Peer Review of Flood Modelling undertaken for the Macintyre River Floodplain

Inland Rail Project
North Star to Queensland Border (NS2B)

Goondiwindi Regional Council

1283-02-D1, 27 November 2020

Figure 4-2 - Extents of the adopted hydrologic and hydraulic models

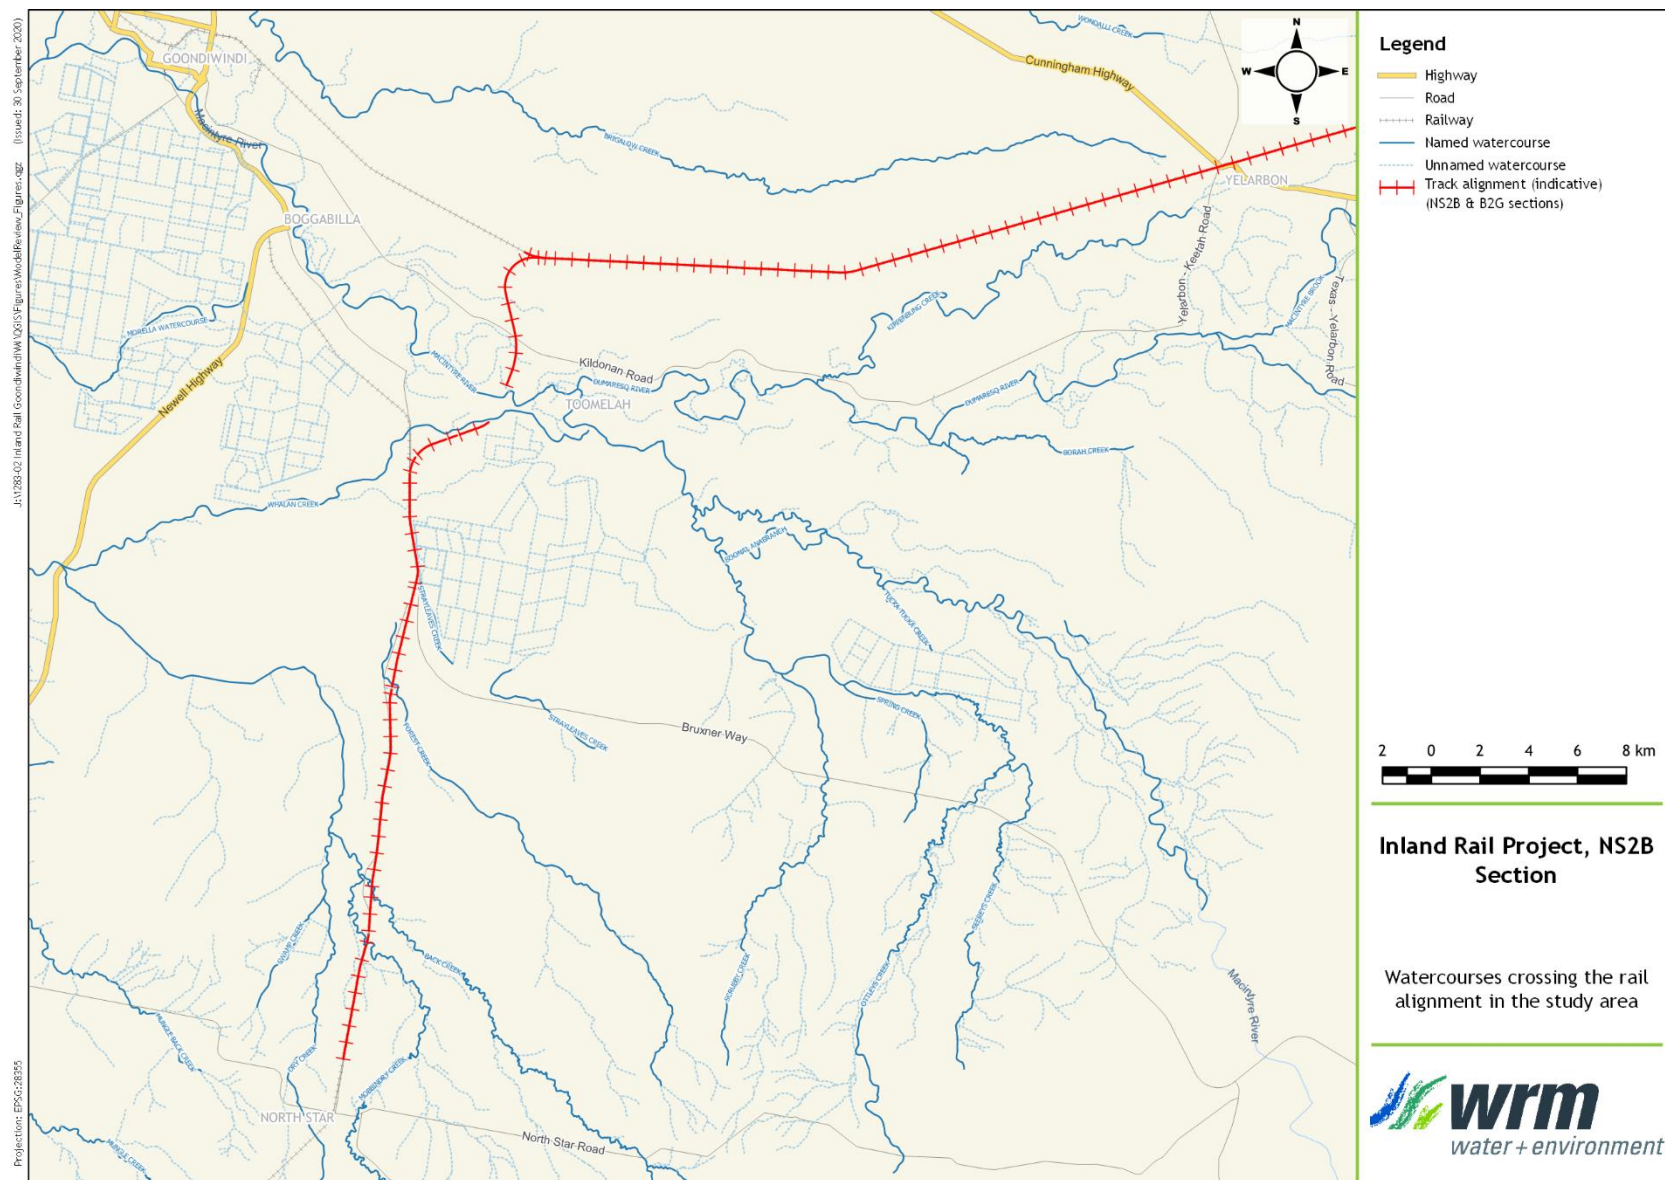
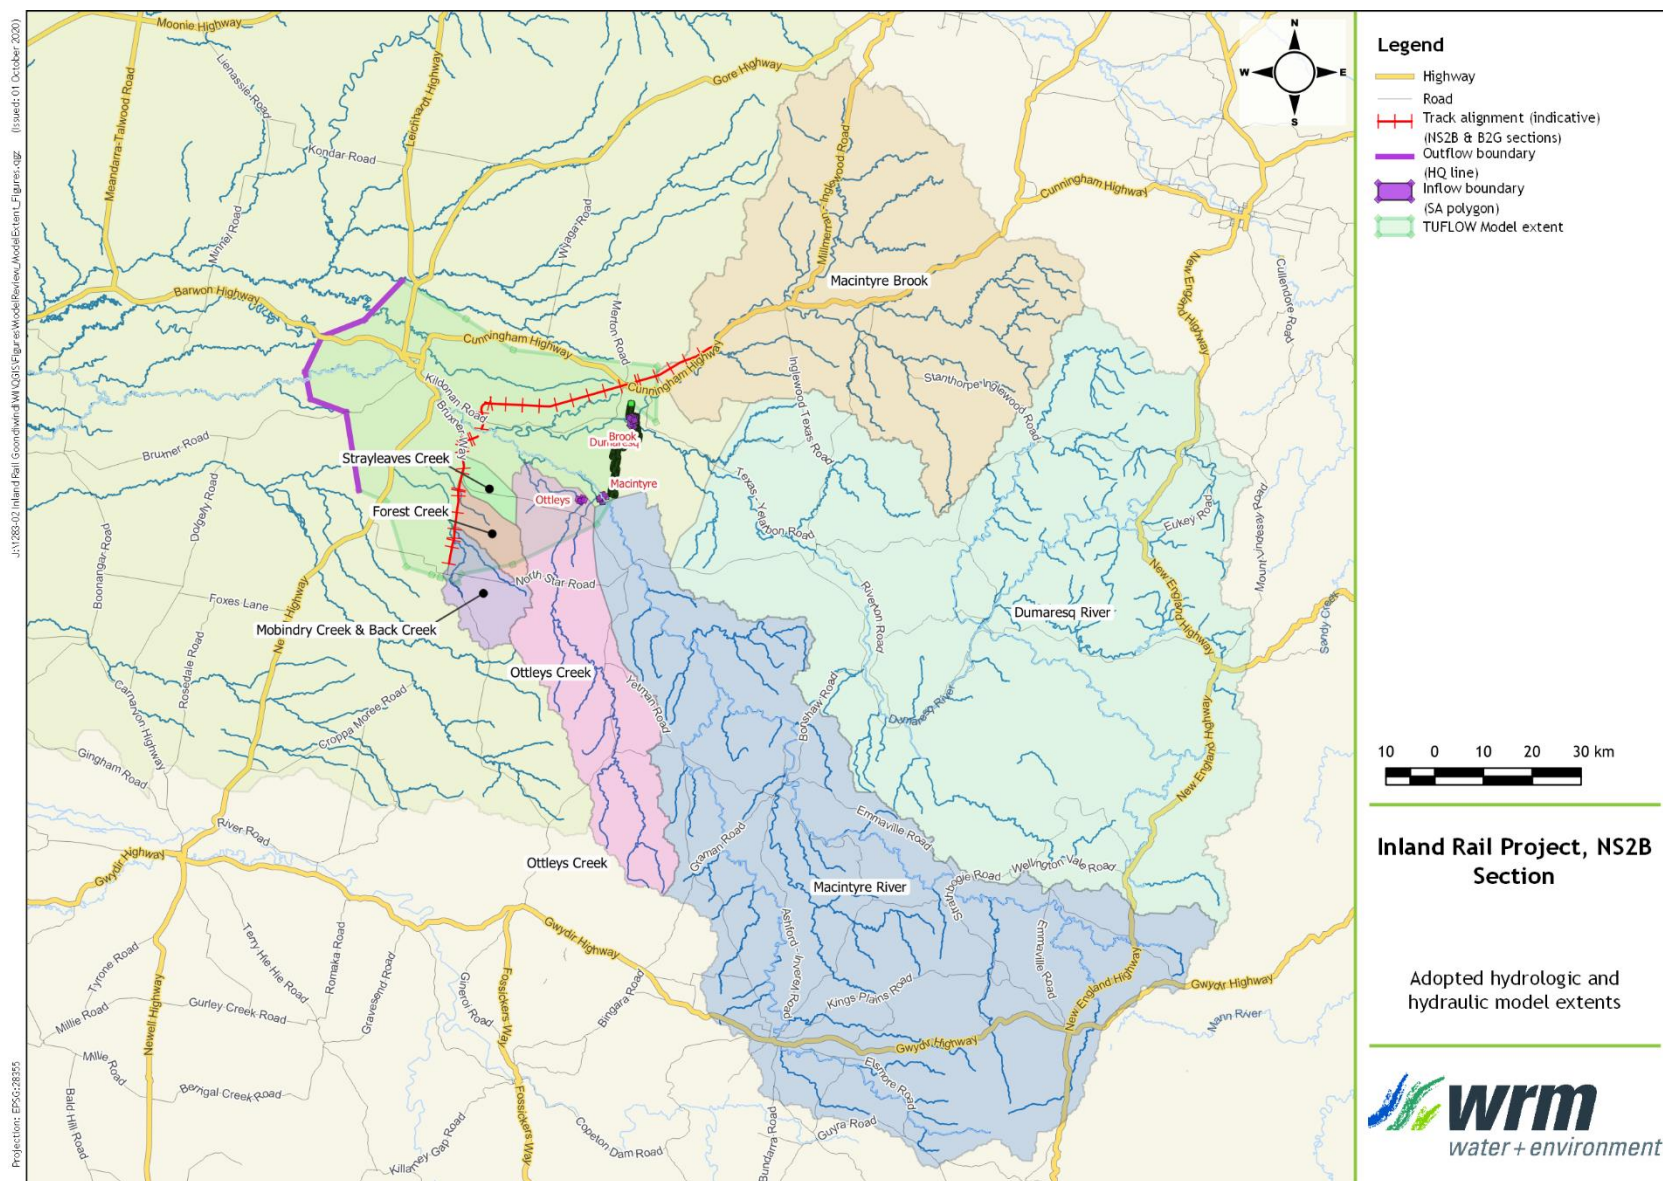
The hydrologic models used for the NS2B flood modelling do not cover the total catchment draining to the modelled area (see Figure 4-2). The hydraulic model extends downstream of Goondiwindi but the hydrologic models do not extend far enough downstream to cover the extent of the hydraulic model. As a consequence, the adopted hydrologic models do not account for local catchment inflows to the hydraulic model area from an area of about 3,250 km², and of this, about 2,050 km² is upstream of the NS2B alignment (see Figure 4-2).

Figure 4-2 shows the adopted extent of the FFJV hydraulic model. The available DEM suggests that there are potential interactions between Macintyre Brook and Kippenbung Creek as well as Brigalow Creek at Yelarbon, as well as Macintyre River and Brigalow Creek upstream of Goondiwindi, during large flood events. This inference from the DEM is consistent with information provided to me by Eddie Belling, a local landholder who is quite familiar with historical flooding behaviour in the Macintyre River catchment. According to Eddie Belling there were significant breakouts from the Macintyre Brook into Kippenbung Creek and Brigalow Creek during the 1956 flood event. Figure 4-3 shows these potential locations of interactions between the modelled waterways and waterways external to the modelled area. It appears that these potential interactions have not been adequately considered when configuring the hydraulic model for large flood events, especially when accurate modelling is required to be undertaken up to the PMF event.

Figure 4-4 - Locations of adopted hydraulic model inflow boundaries, calibration events

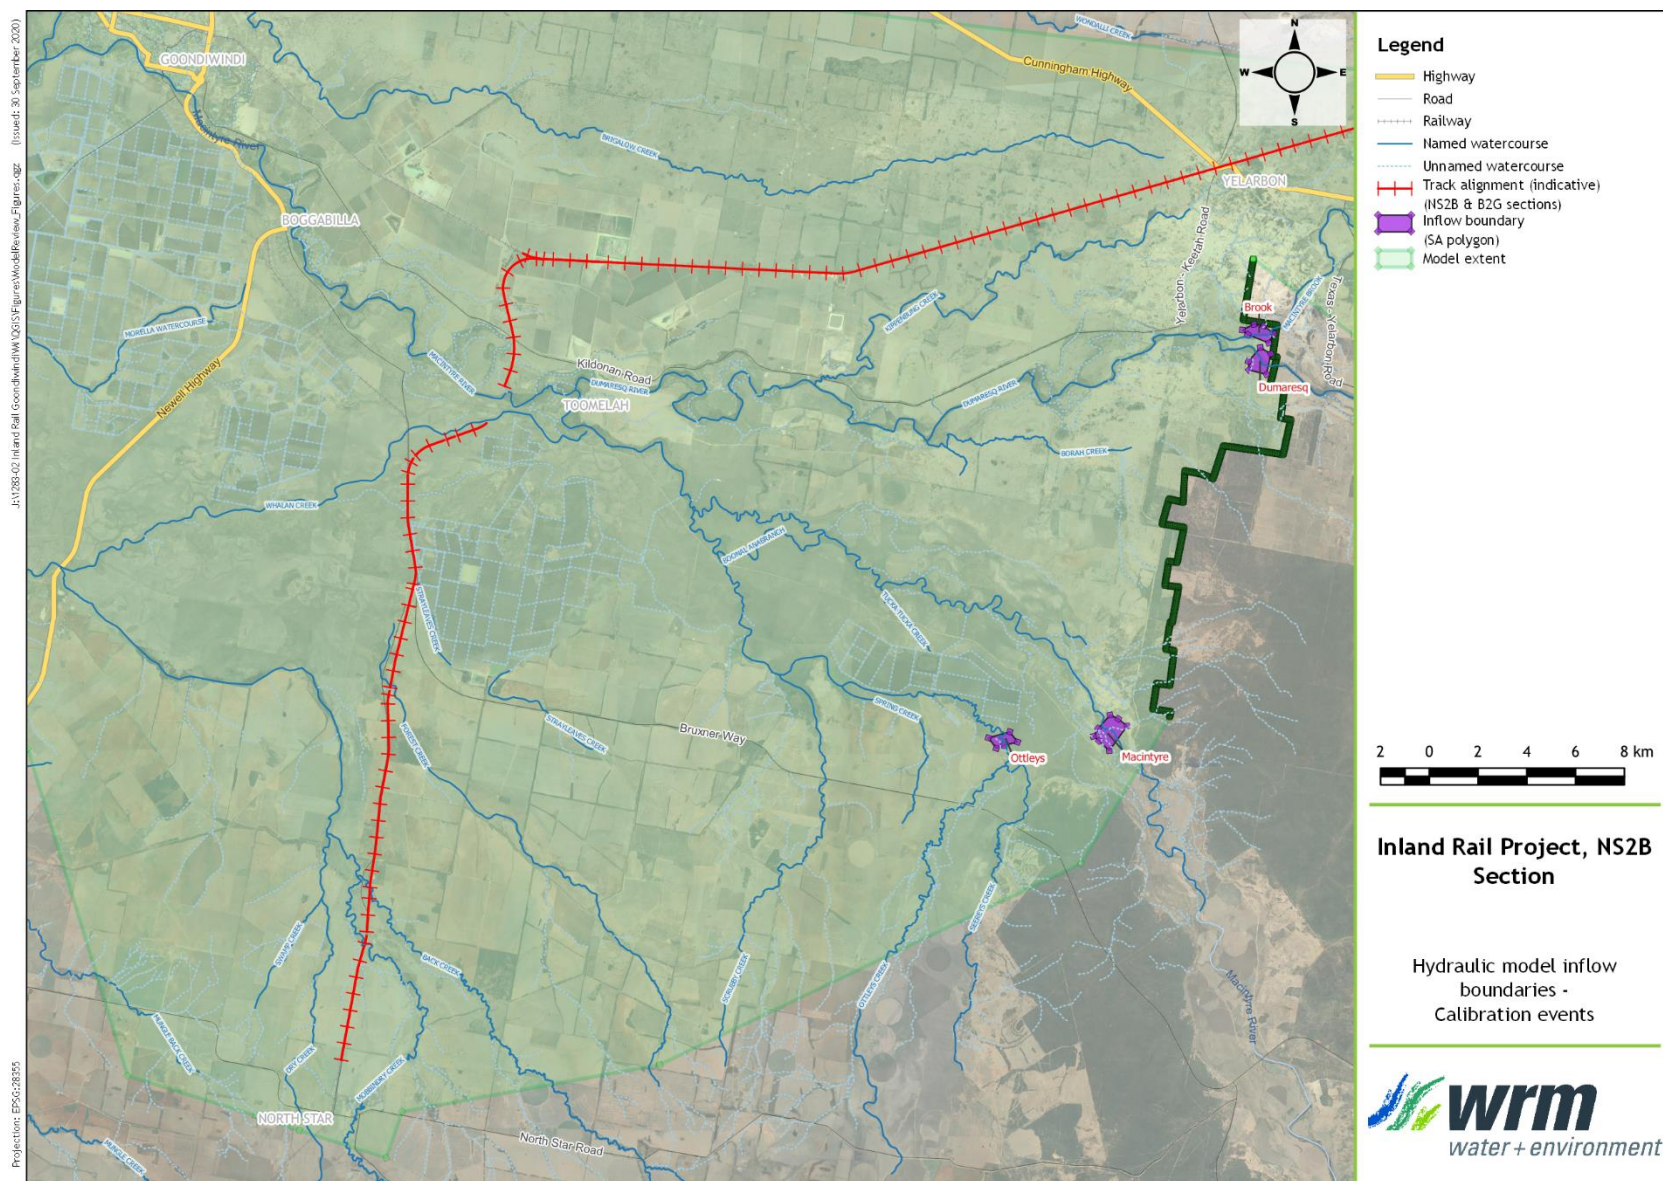
Figure 4-4 and Figure 4-5 show the locations (i.e. placements) of inflow boundary conditions in the hydraulic model for calibration events and design events respectively. The placement of model inflow boundaries raises a number of significant issues with respect to accuracy and reliability of model results, including:

In response to my queries, FFJV have stated that their inflow placements are as per the DPIE model, with the exception of Ottleys Creek, which has been shifted upstream to better represent the flow around drainage structures. If the Ottleys Creek inflow location could be changed, I see no reason why FFJV could not also change some of the other DPIE model inflow locations (e.g. Macintyre Brook) to better represent the inflows to the modelled area.

Figure 4-5 - Locations of adopted hydraulic model inflow boundaries, design events

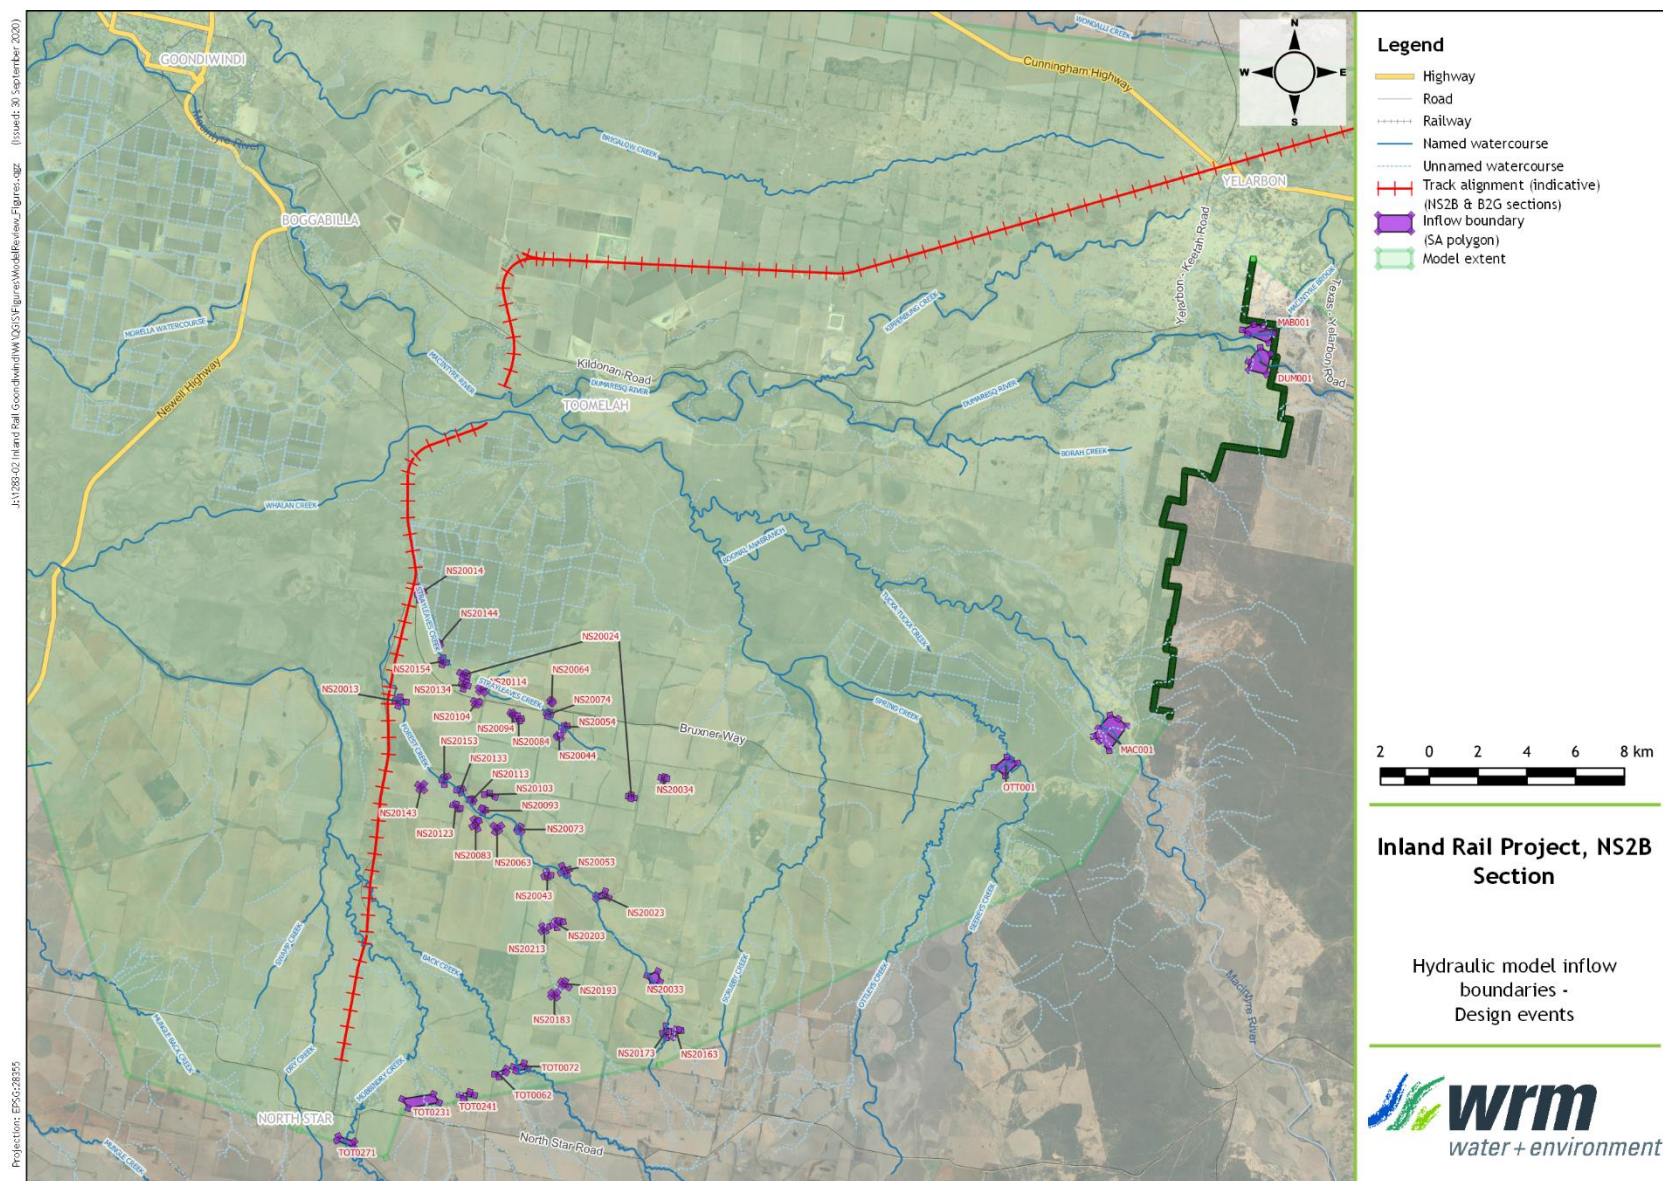
For Forest Creek and Strayleaves Creek, all adopted local inflows appear to be a scaled version of each other, with the same hydrograph shape and timing at all inflow locations along these creeks as shown in Figure 7-1. It also appears that the same inflow has been incorrectly allocated to two locations (labelled NS20024) along Strayleaves Creek as shown in Figure 4-5.

Figure 4-6 - Approximate locations where hydraulic structures may not be adequately represented in the TUFLOW model

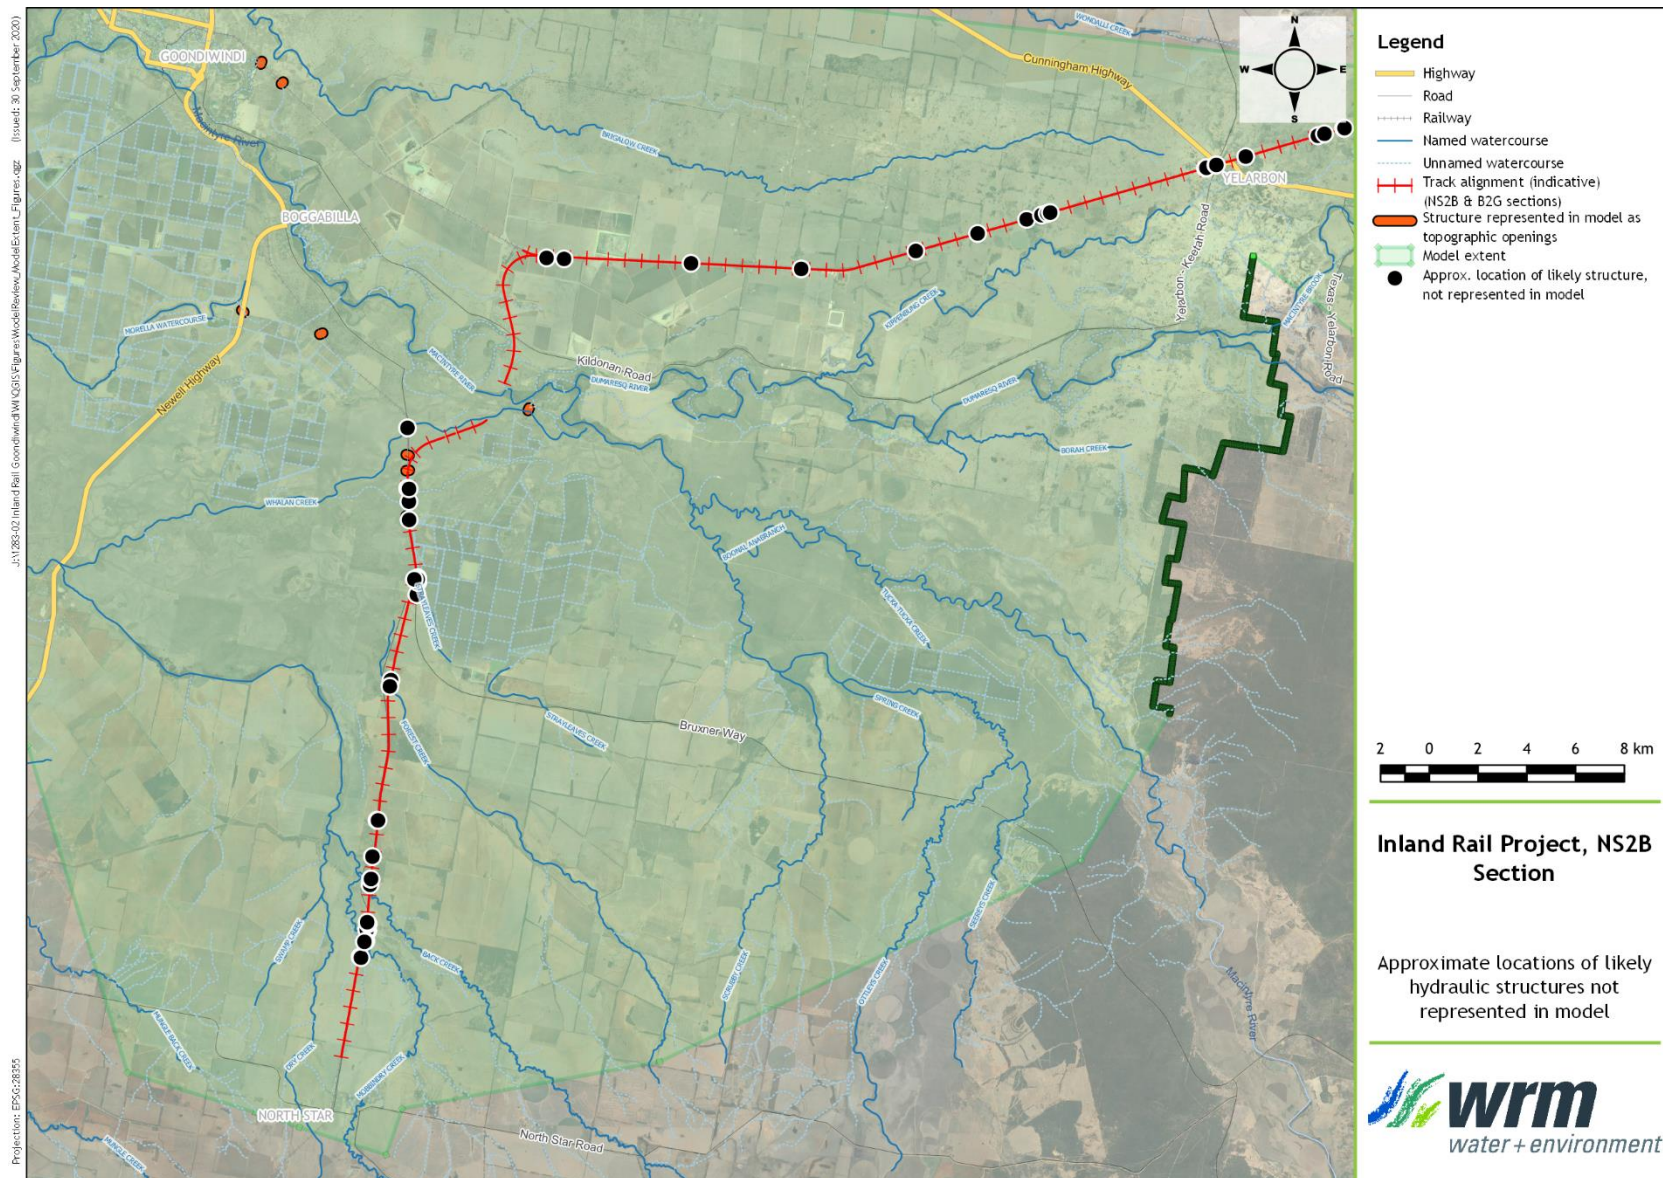
There appears to be a number of cross drainage structures along the existing rail and road alignments which are not represented in the hydraulic model under existing conditions (e.g. road cross drainage and bridge structures) because the LiDAR appears to be read in 'as-is', without adequate openings or other modifications. However, these structures are being represented under developed conditions (e.g. Mobbindry Creek, Back Creek) with designed hydraulic structures. Some of the approximate locations where existing hydraulic structures may not be adequately represented are shown in Figure 4-6.

In response to one of my queries, FFJV has stated that minor hydraulic structures that are exposed to major flood inundation are not included in the hydraulic model. As described earlier, some of these structures appear to be along the existing road and rail corridors. The non-inclusion of these structures, with appropriate blockage factors, has the potential to significantly underestimate the impact of the proposed rail line especially during small flood events and when assessing potential impacts on future access to private properties. Some examples of these impacts are presented in Section 7.3.5.
